TAS 26-15A / D215083

Rehabilitation of the Wastewater Treatment Plant at the Chittenango Service Area I-90, Milepost 266.3 Westbound in Madison County

QUESTIONS AND ANSWERS

February 12, 2026

Supplementary Information - 1 (Photograph) of Facility similar to project facility

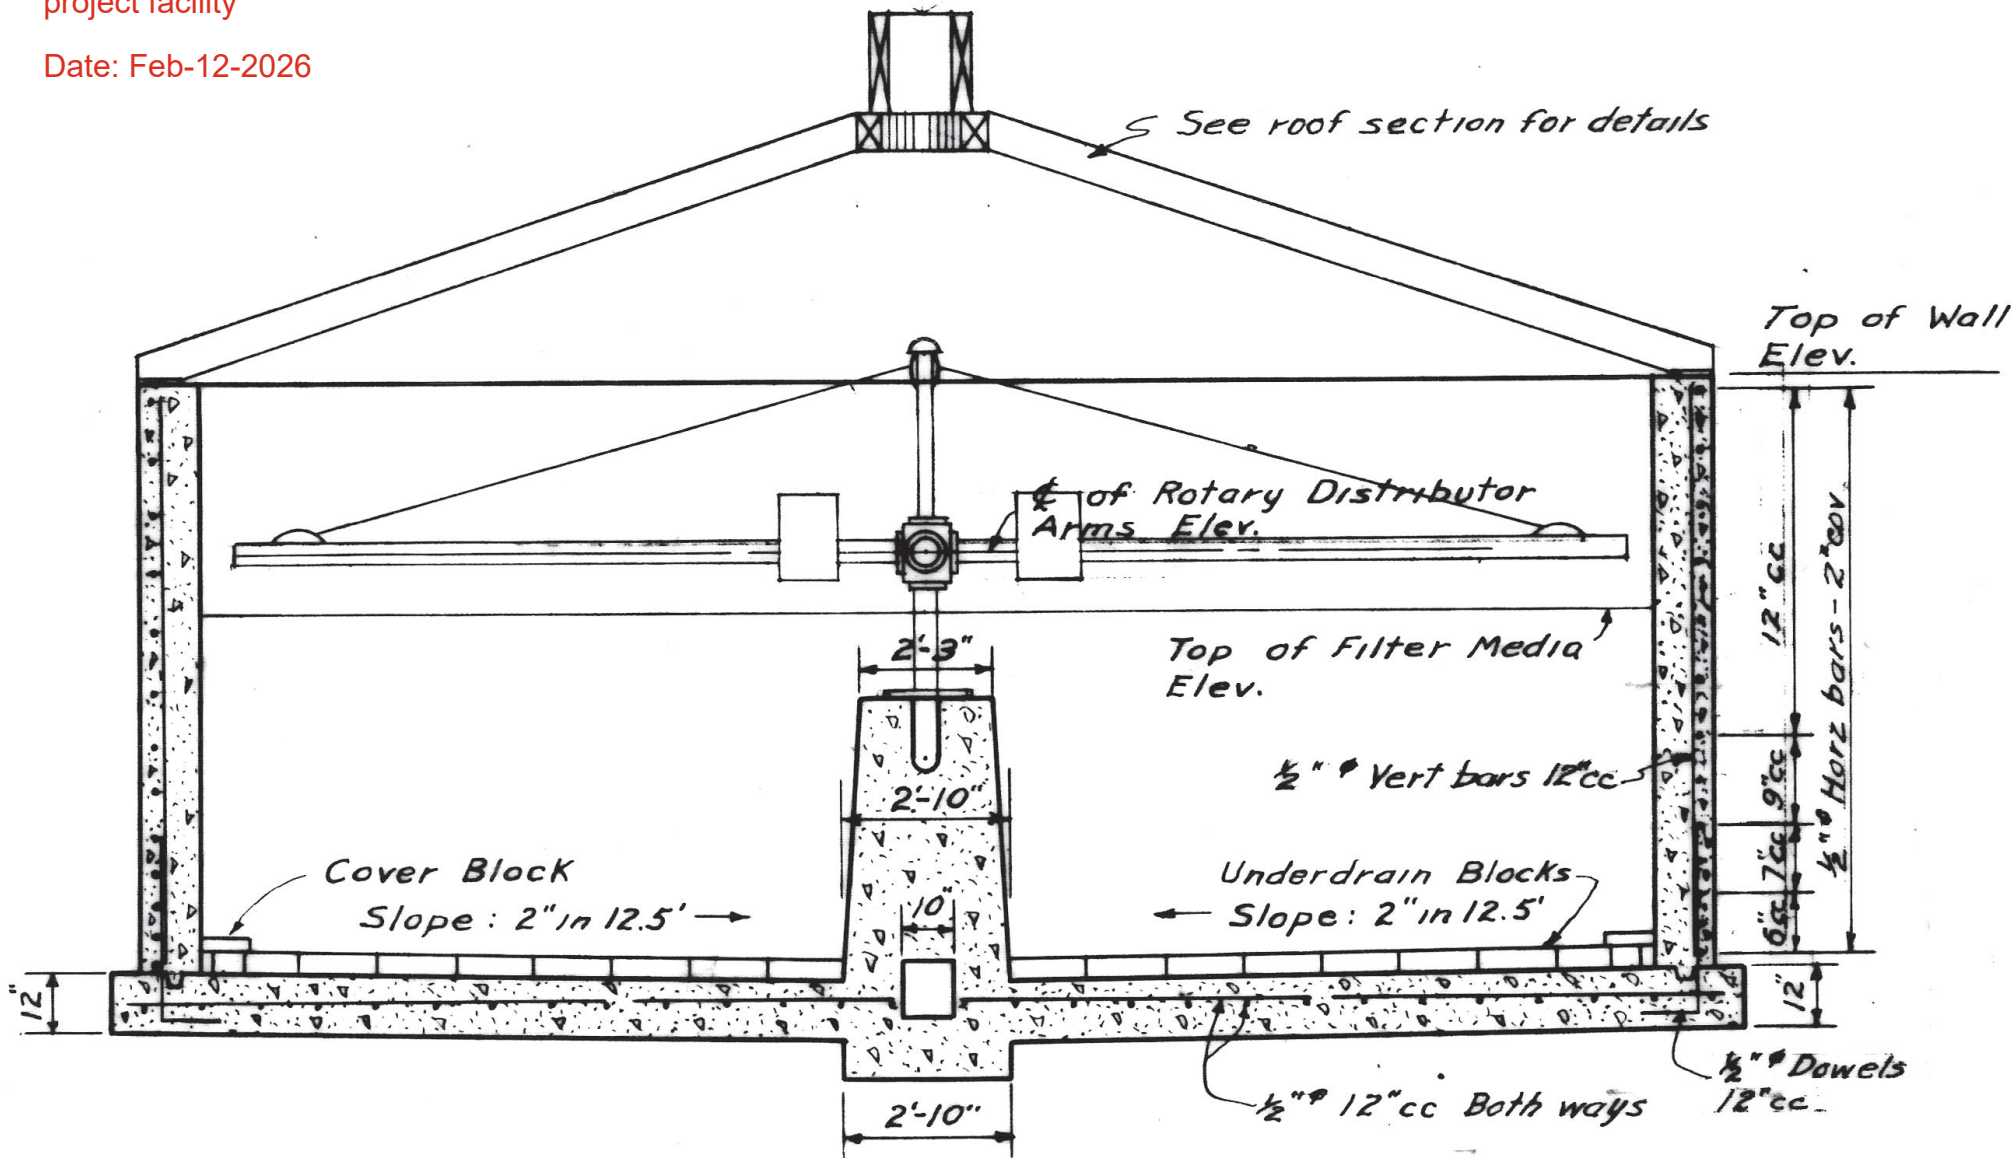
- Q2. On Drawing C-1 Note 4 states to demolish the existing tricking filter. Please provide a record drawing for the trickling filter to determine the depth of the existing tank.

- A2. A record drawing of the existing trickling filter is being provided as an attachment to this document.
- Q3. On Drawing C-1 Note 11 states to demolish the existing Sand bed. Please provide a record drawing for the Sand bed to determine the depth of the existing Structure.
